**WEST WILSON UTILITY DISTRICT  
REQUEST FOR PROPOSALS – FILTER EQUIPMENT**

**ADDENDUM NO. 2**

**PROJECT:** Request for Proposals – Filter Equipment  
**BID DATE/TIME:** July 24, 2025, at 2:00 PM local time  
**OWNER:** West Wilson Utility District  
**DATE:** July 17, 2025  
**NO. OF PAGES:** 3

**Filter Example**

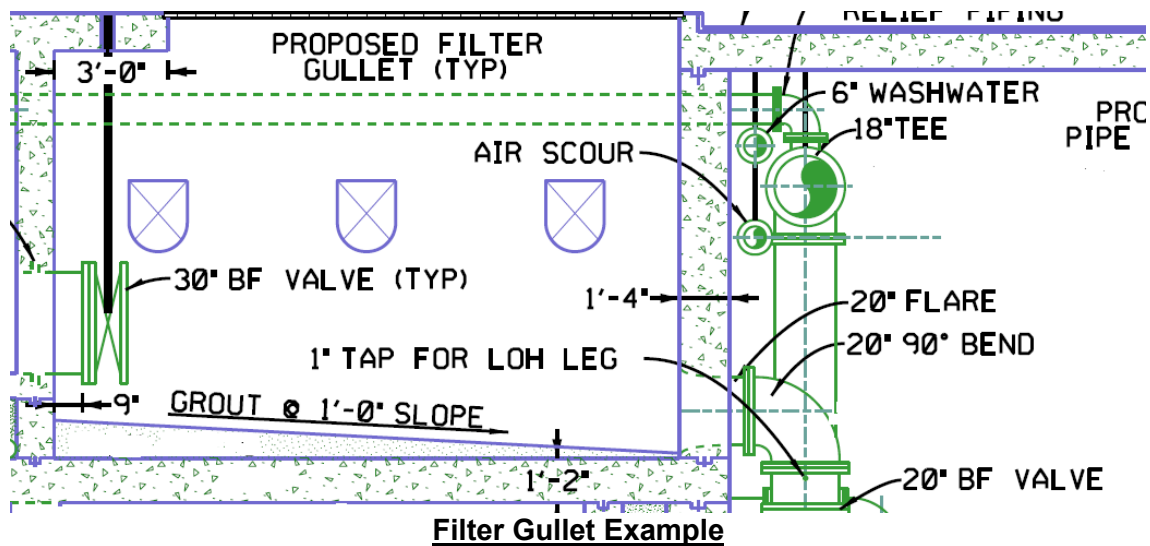
1. PROPOSER shall provide three (3) hard copies and one (1) USB drive including a full electronic copy of PROPOSAL.
2. Pre-Approved manufacturers are Leopold and Roberts Filter. Pre-Approval does not absolve PROPOSER from ensuring all necessary documents (as noted in RFP) are included in PROPOSAL submission.
3. Filter dimensions are 16.5'x16.5'x12.0' (Approx.).

**Preliminary Layout**

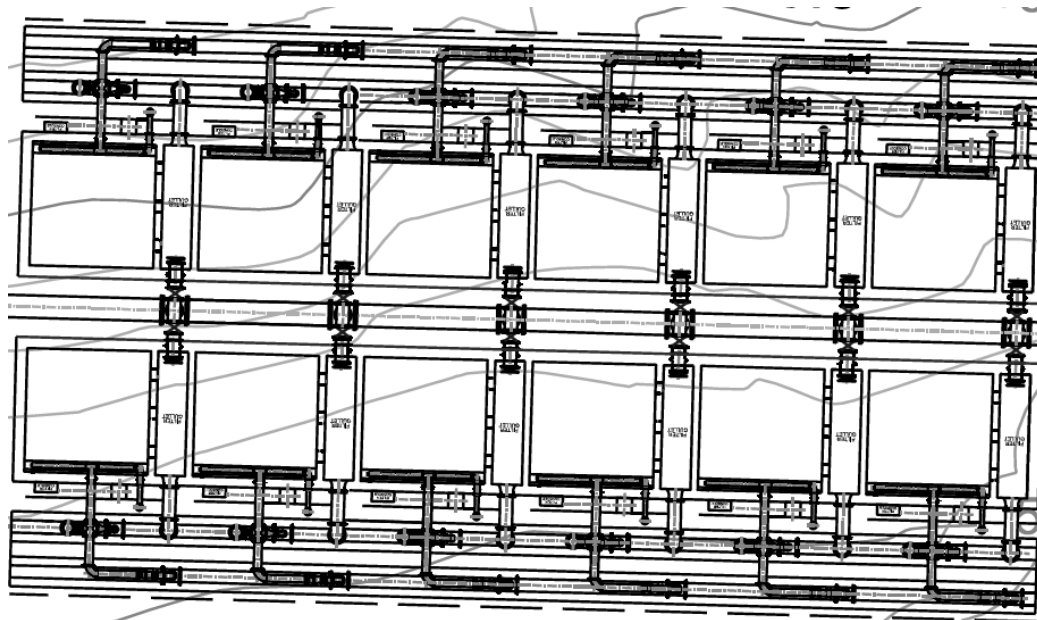
4. PROPOSER shall provide pricing for a "BASE" Proposal Price for a filter system including twelve (12) total filters. PROPOSER shall provide "DEDUCTIVE" Proposal Pricing for eight (8) total filters. Each Proposal Price shall include the total cost associated with furnishing, shipping, startup, etc... the respective quantity of filters along with all necessary equipment, including, but not limited to: controls, panels, troughs, underdrains, media, air scour, compressors, etc... to ensure a complete and working system.
